Docket Number:	15-AAER-02
Project Title:	Pool Pumps and Spa Labeling
TN #:	212253
Document Title:	Presentation APSP Review of CEC Staff Report on Portable Electric Spas
Description:	Review of CEC Staff Report, Revised Analysis of Efficiency Standards for Pool Pumps and Motors, and Spas
Filer:	Sean Steffensen
Organization:	The Association of Pool & Spa Professionals (APSP)
Submitter Role:	Public
Submission Date:	7/12/2016 2:17:51 PM
Docketed Date:	7/12/2016

Review of CEC Staff Report Revised Analysis of Efficiency Standards for Pool Pumps and Motors, and Spas Docket Number 15-AAER-02

CEC Proposed Energy label

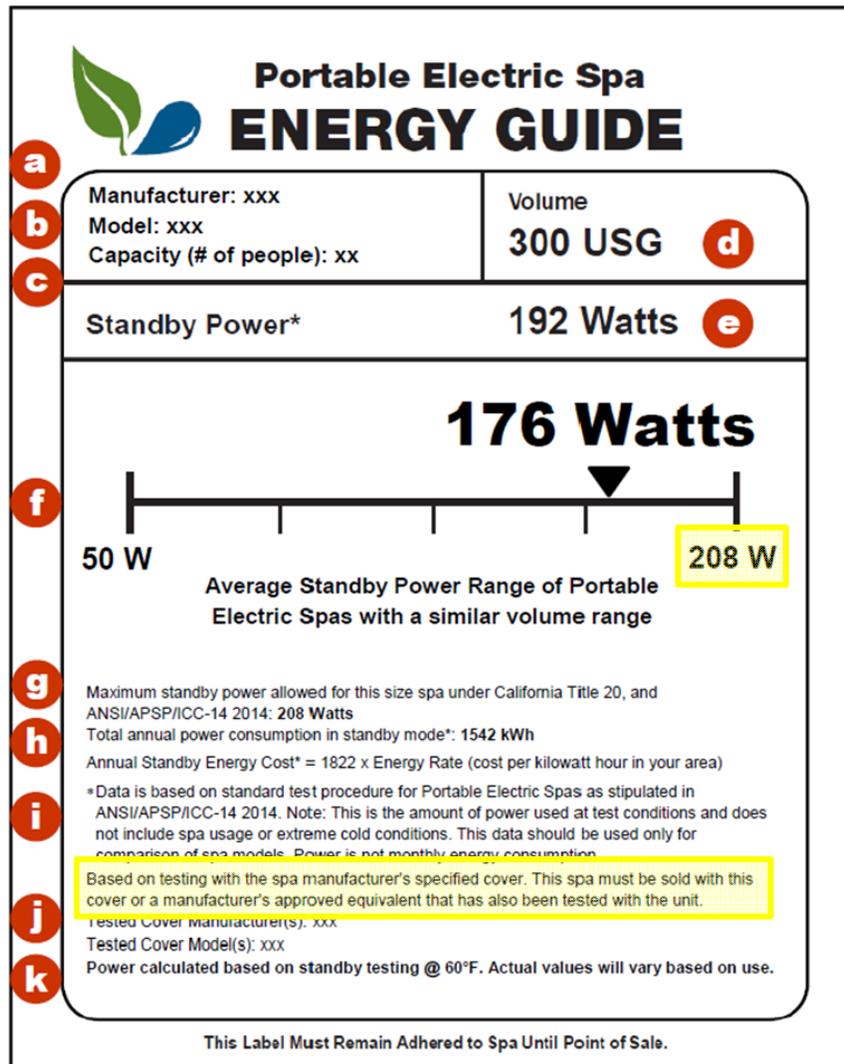
Changes:

- Bar chart maximum limit set by individual spa's max allowed energy.
- Additional language specifying cover must be tested on the spa.

- An energy bar chart based on spa maximum allowable energy by volume is only comparable to itself.
- The visual guide can drive people to purchase higher energy using spas.

Label Recommendation

- Use the existing industry label comparing the industry spas as a whole.
- The label could push people to purchase spas that use less energy.

Which Spa is Better?

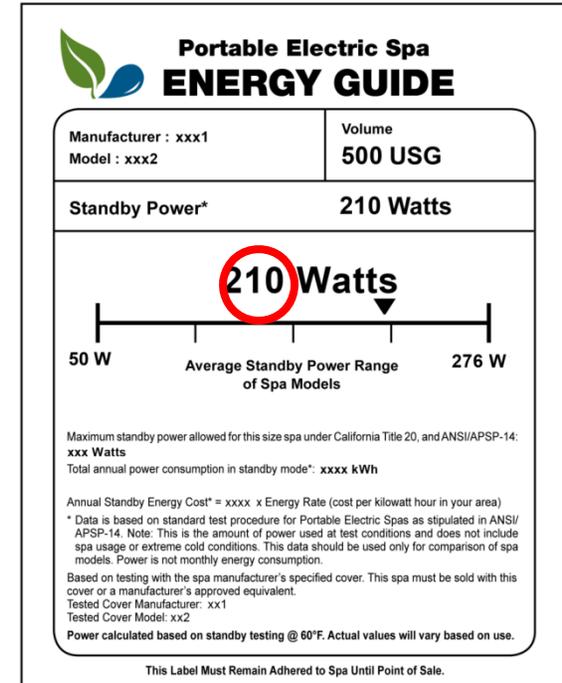
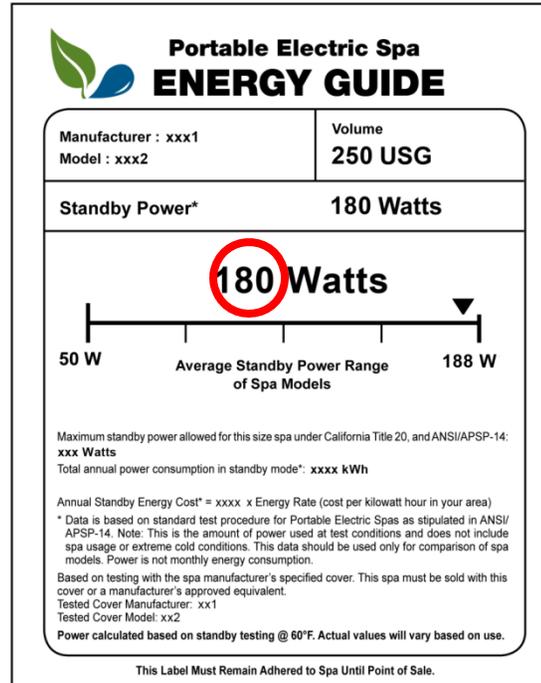
Spa A is the true better spa for California. It uses less energy over all.
